Wesley Avenue, Netherthong

Road Safety Audit Stage 1 / 2

Project number 2128(A)

Wesley Avenue, Netherthong – Road Safety Audit Stage 1 / 2 (Internal adoptable road).

Client	HEYWOOD DEVELOPMENTS
Project	WESLEY AVENUE, NETHERTHONG
Detail	VEHICLE TRACKING PLAN
Dwg No.	E22/7931/034B
Date	JAN'2023
Scale	1/250 @A1
Drawn	JM
Checked	MH

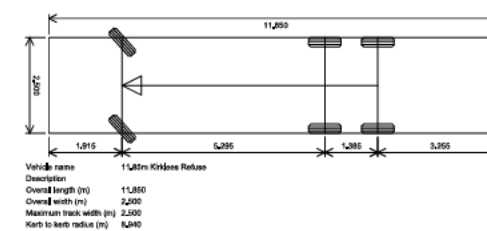
It is unclear what is proposed for the existing turning head. The footways appear to continue through to create a continuation of the traditional estate road. This may lead to a level difference between the rear of the footway and existing turning head level providing a trip hazard for pedestrians. Furthermore, these areas may be used by neighbouring properties for parking, which given the depth from the rear of the proposed footway, would lead to a parking vehicle obstructing the footway resulting in pedestrians negotiating the carriageway increasing the risk of a vehicle colliding with a pedestrian.

The turning head should ideally have a maximum gradient of 1 in 20. Steeper gradients within turning heads can cause loss of control type collisions when carrying out tight turning movements increasing the risk of a turning HGV (such as large refuse vehicle) inadvertently overrunning the adjacent footway and colliding with a pedestrian or other object leading to injury.

It is unclear if boundary treatment at either side of the driveway as it meets the adoptable road would obstruct intervisibility between other road users or pedestrians when emerging from the driveway. Failure to provide suitable visibility at the access could lead to a vehicle emerging into the path of an oncoming car or pedestrian resulting in a collision or sudden braking and loss of control type collisions.

It is unclear if car parking can be fully accommodated off street to serve each dwelling having regard to the requirement for 3 spaces for 4-bedroom dwellings. Failure to provide suitable off-street parking could lead to excessive parking on street, which could lead to obstructions for larger vehicles (such as refuse vehicles or emergency vehicles). This would increase the risk of larger vehicles either colliding with other vehicles when attempting to negotiate parked vehicles injuring occupants, or lengthy reversing movements increasing the risk of a reversing vehicle colliding with an NMU.

It is not clear if the plot is located within pump distance for a fire appliance. Failure to provide suitable fire tender access could lead to lengthy reversing movements along the access and within the proposed adoptable road increasing the risk of a vulnerable road user.

The scheme proposes driveways to the front of the dwellings inevitably resulting in a long dropped vehicular crossing. Overly long footway crossings and low kerbs can excessively expose pedestrians to multiple turning / reversing movements increasing the risk of a vehicle colliding with a pedestrian.

No detailed information has been provided in relation to the provision of street lighting on the adoptable road. Inadequate street lighting can lead to pedestrian trip type incidents during the hours of darkness and reduces intervisibility between motorised traffic and vulnerable road users, increasing the risk of a collision.

The proposals include details on how the redundant turning head areas are to be removed.

The turning head gradient be reduced to a minimum of 1 in 20.

The visibility splay provision and confirmation low boundary treatment should be provided where the access meets the adoptable road.

Details should be provided confirming suitable parking provision for each dwelling in accordance with KMC requirements.

Confirmation should be provided that the dwelling is within 45m of the adoptable road. If not, then a swept path analysis should be submitted to the Audit Team demonstrating that these vehicles can either access the site without reversing more than 20m.

The parking is reconfigured so that some separation is provided between dropped kerbs so that a full-face kerb can be provided reducing the length of uninterrupted dropped kerbs.

A street lighting scheme for the whole of the development should be submitted to the Audit Team for consideration.
